Access Compliance Report

Public Rights-of-Way

(Pedestrian Signals)

Intersection ID: N/A	Main Street:	Cross Street: N/A	Location: N/A
ADA ID: 94A0F8A9EF76	Signal Type: One Push Button-Non APS	Overall Compliance: No	Severity Score: BTN 1: N/A BTN 2: N/A No BTN: N/A
Codes/Mitigation Info/Possible Solution		Field Measurements/Component Compliance

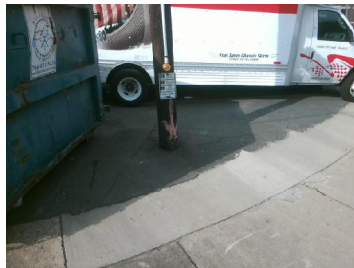
Surveyor Notes: TEXT HT 7/16, CLEAR SPACE WITH ASP MATERIAL

PROW/ADA: R410.6, TMUTCD 4e.08, R404.2

Possible Solutions: Replace Signal Push Button With APS Button on New Post. Remove & Replace Sign.
